Access Compliance Report

Public Rights-of-Way

(Curb Ramps)

Intersection ID: 48429	Main Street: ROUSAY_RD	Cross Street: SEAMILL_RD	Location: NE
ADA ID: 307969D752B5	Ramp Type: PerpDiag	Initial Pass/Fail: Fail	Overall Compliance: No
			Severity Score: 46.25

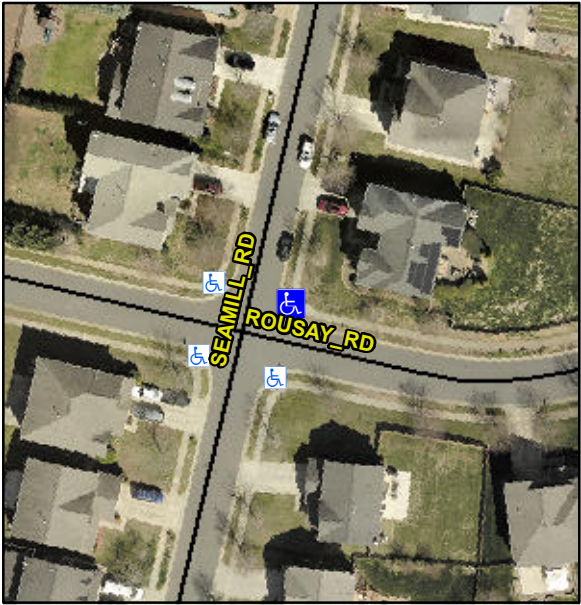
Codes/Mitigation Info/Possible Solution			Field Measurements/Component Compliance		
	Possible Solutions:		Compliance	Description	Data
	Remove & Replace Curb Ramp With Two New Directional Ramps or Equivalent.		No	Ramp Length (in)	47.0
			No	Ramp Width (in)	46.0
			N/A	Flare Type LT	N/A
			N/A	Flare Slope LT (%)	N/A
			N/A	Flare Traversable LT?	N/A
			N/A	Landing Length (in)	N/A
			N/A	Landing Width (in)	N/A
			N/A	Landing Slope (%)	N/A
			N/A	Landing X Slope (%)	N/A
<p>Surveyor Notes:</p> <p>N/A</p> <p>PROW/ADA:</p> <p>Not Found, R304.5.1, R304.2.2, R304.5.3</p>			N/A	Flare Type RT	N/A
			N/A	Flare Slope RT (%)	N/A
			N/A	Flare Traversable RT?	N/A
			N/A	DWS Provided?	N/A
			N/A	DWS Contrast?	N/A
			N/A	DWS Length (in)	N/A
			N/A	DWS Full Width?	N/A
			N/A	DWS Offset (in)	N/A
			N/A	Shared Landing?	N/A
			N/A	Gutter Ponding?	N/A
			N/A	Gutter Lip Ht (in)	N/A
			N/A	Painted X Walk1?	No
				X Walk 1 Direction	To NW

N/A	X Walk 1 Width (in)	N/A
				X Walk 1 Slope (%)	7.8
				X Walk 1 X Slope (%)	4.3
			N/A	Ramp inside XWalk1?	N/A
				Road Slope (%)	7.3
				Road X Slope (%)	2.6
			N/A	Any Obstructions?	N/A
				Obstruction Type	
Total Cost:		\$ 3200.00			
			N/A		N/A
			Yes	Surface Condition? (G/P)	Good
